CUSTOMER NOTIFICATION

ZUD-CD-10-0015 (1/9)
January 22, 2010
Yoshinari Ando, Team Manager Development Tool Solution Group Multipurpose Microcomputer Systems Division Microcomputer Operations Unit NEC Electronics Corporation

QB-78K0RIX3
(Control Code: A, B, C, D, E)

Operating Precautions

No. 7 Program execution on RAM

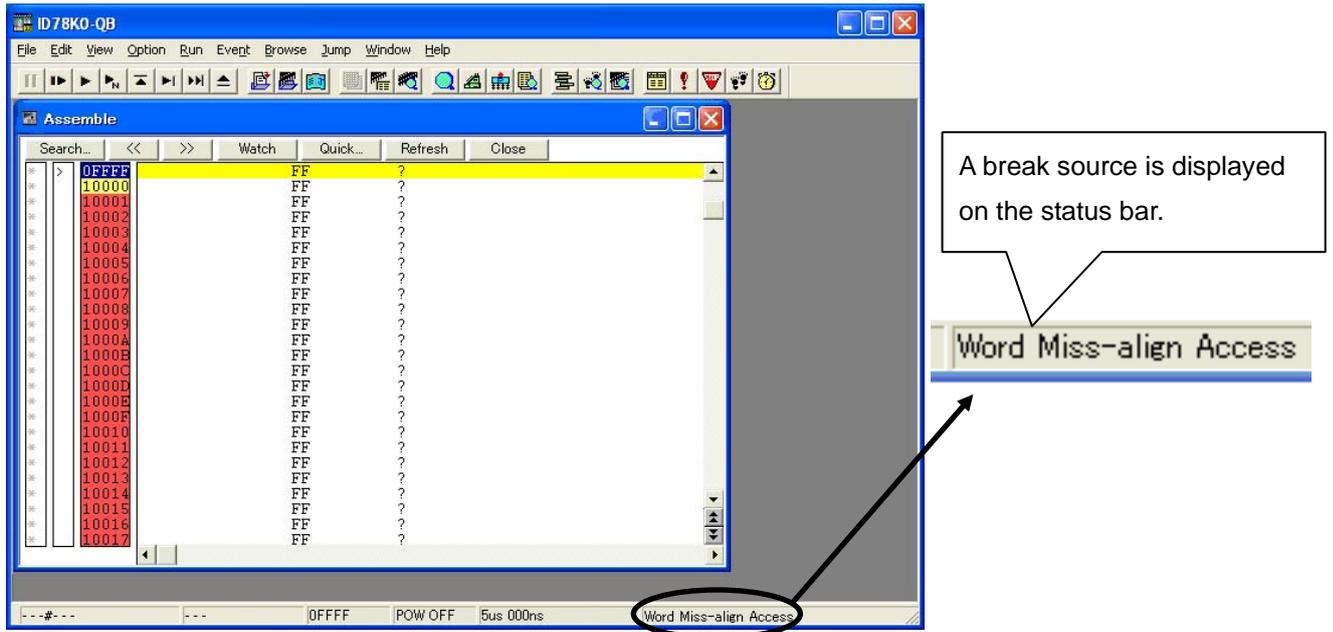
When a branch instruction is executed on RAM and if the branch destination is an odd address located in RAM, a fail-safe break due to a word misalign access occurs.

Clear the check box for the [Word Miss-align Access] in the Fail-Safe Break dialog box in the ID78K0R-QB.

A break source can be checked in the status bar in the ID78K0R-QB, as shown below.

This issue has been corrected in products with control code D and later.

No. 9 Restriction on trace data when an interrupt occurs (2)

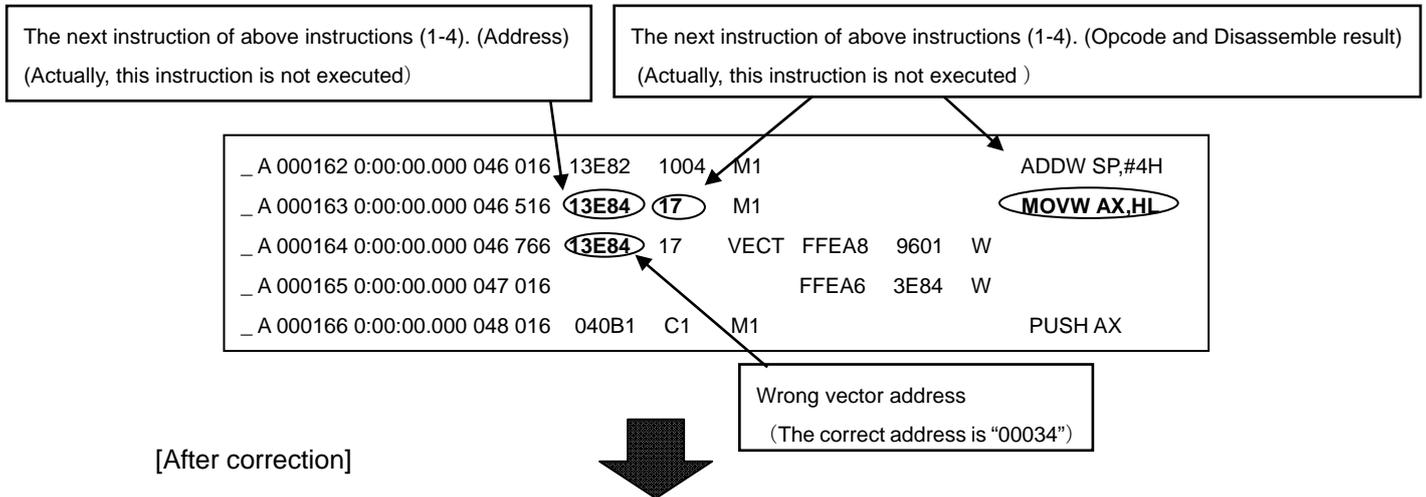
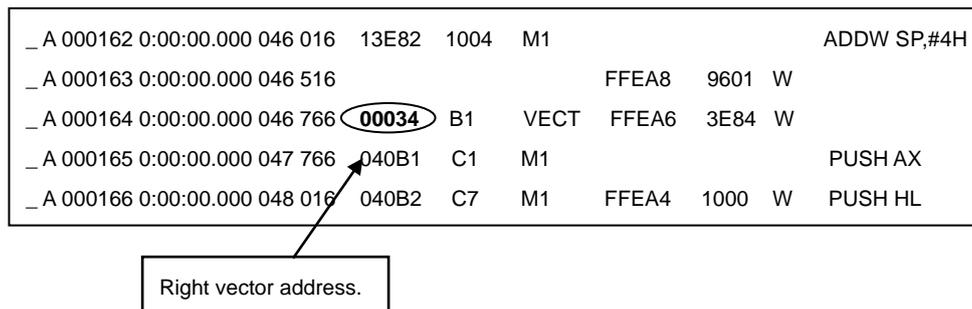
If interrupt request occurs by the specific condition, a trace result may not be correct.

When branching to interrupt vector just after executing one of following instructions, a trace result may not be correct.

When branching to interrupt vector just after executing the above instructions (1-4), the next instruction of above instructions (1-4) is not executed, thus it is not displayed on trace window. But the following contents are displayed on trace window actually.

This issue has been corrected in products with control code E or later.

An example of trace data before and after the correction of this restriction is shown below.
